## **NOTICE OF PUBLIC HEARING** **Minor Variance**

**APPLICATION NO.:** HM/A-22:50

**SUBJECT PROPERTY:** Municipal address **61 Harmony Ave., Hamilton**

**PROPOSAL:** To permit alterations to the existing single family dwelling including covering and enclosing the existing front porch to form part of the dwelling, and the construction of a new unenclosed porch and associated stairs in the front yard, notwithstanding that;

## 61 HARMONY AVE. PLOT PLAN

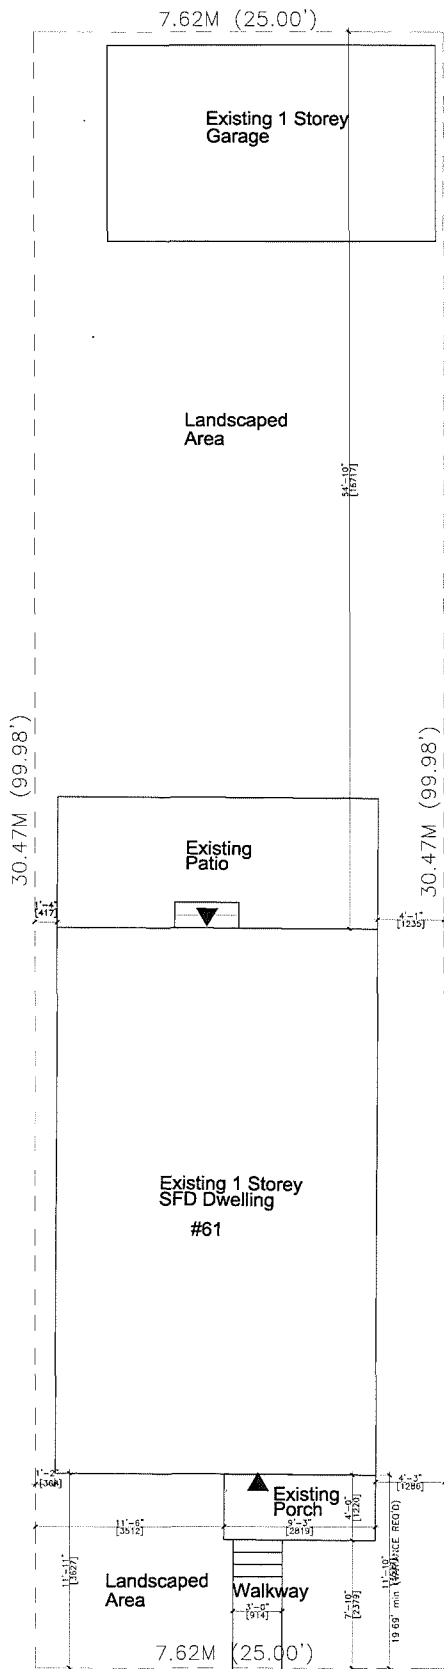
1. Please note that the height of the existing porch that is to be covered and enclosed to form part of the dwelling has not been indicated on the submitted elevation drawing as per the definition of Height provided in Hamilton Zoning By-law No. 6593. As per Section 9(2), no building shall exceed two and a half storeys, and no structure shall exceed 11.0 metres in height. Additional variances may be required if compliance with Section 9(2) cannot be achieved.

2. Please note that the submitted site plan indicates side yards of varying widths. This zoning compliance review is based on the minimum side yard widths indicated for the principle dwelling as indicated in the Site Statistics i.e. northerly side yard indicated as a minimum of 0.99 metres and the southerly side yard indicated as a minimum of 0.30 metres. Please note that with respect to Variance No.2, as per Section 9(3)(ii) and Section 18(3)(v), the minimum required side yard width is 0.9 metres as the subject lot is a Lot of Record as defined in Hamilton Zoning By-law No. 6593.

3. Please note the projection of the eaves/gutters of the existing porch that is to be covered and enclosed to form part of the dwelling has not been indicated. Should Variance No.1 be granted to permit a minimum front yard of 3.5 metres, and Variance No. 2 be granted to permit a minimum southerly side yard of 0.30 metres, as per Section 18(3)(vi)(b) eaves/gutters shall be permitted to project into the newly established minimum

front yard not more than 1.5 metres, and shall be permitted to project into the required side yard(s) not more than one half its width. Additional variances may be required if compliance with Section 18(3)(vi)(b) cannot be achieved.
